**Planning, Land Use and Mobility Committee**

**Case Report:**           **New Single Family Residence**  
**DIR 2019-4606--DRB-SPP-MSP**  
**21075 Topochico Drive.**  
**Woodland Hills, CA 91364**

**PLUM Hearings:**       **January 23, 2020 (First presentation)**  
**February 6, 2020**  
**August 6, 2020**

**Project:**               **Application for a Permit for construction of a 2-story, 2820 SF Single Family Residence and attached two car garage in the Girard Tract and the outer core of the Mulholland Scenic Parkway Specific Plan.**

### **Updated rendering of East façade showing balcony and downspouts**

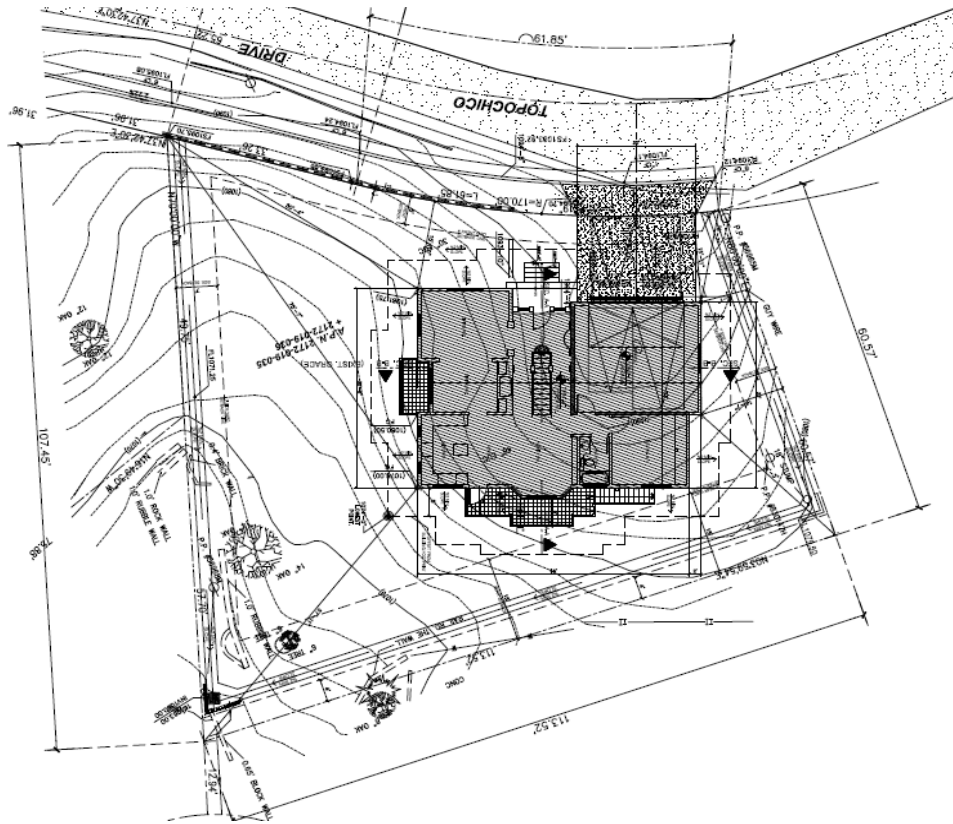
Run-off and drainage from the building will be handled by gutters that channel into several rain barrels on the site. Permeable hillside coverings and planting will allow for even hillside absorption without resulting in major water run-off onto neighboring properties below. Applicant supplied renderings that indicate downspouts from roof barrels.

***South elevation showing second floor balcony with iron railings and initial decorative “stone” enhancement.***

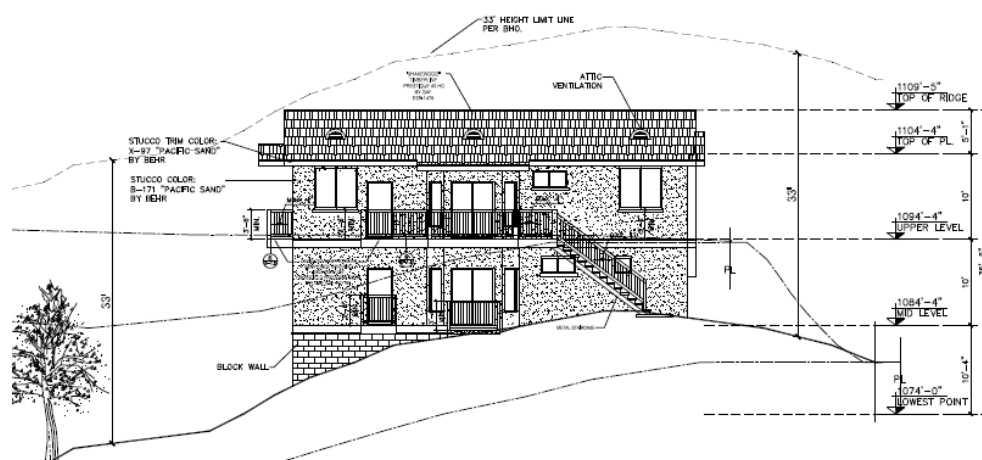
The bulk of the structure sits above the existing grade, with some vertical walls meeting grade and other vertical walls hovering above grade. The lower sections of the North, East and South walls are block with areas visible above the surface of the hill covered with stucco to match the rest of the house. In addition to the “Sand” colored stucco on the exterior walls, exterior materials include “Shakewood” simulated shake roofing tiles and the original plans proposed Canyon Rock “Ledgerstone” simulated stone accents along the lower half of the front façade, the front door archway and on portions of both the South and North elevations. Later renderings show no stone accents.

***Rear (East) façade of the proposed residential structure***

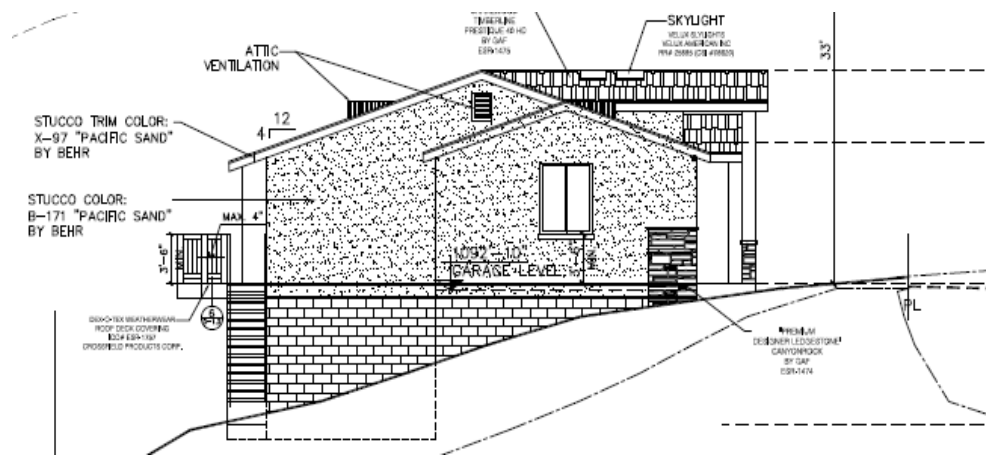
The project as designed appears to address the recommendations, guidelines and requirements of the Girard Tract Specific Plan, the Mulholland Scenic Parkway Specific Plan and the Baseline Hillside Ordinance. Additionally the applicant has answered key PLUM requests such as adding boarding/fencing below driveway bridge to prevent animal habitation, and agreeing to have traffic control flaggers and posted signs whenever there's deliveries or when hauling dirt or pouring concrete. However, in most recent renderings, it appears that stone fascia has been removed and overall design has a more modern appearance. Renderings indicate the mass of the structure to be a dark coloration which may not pass Mulholland DRB.
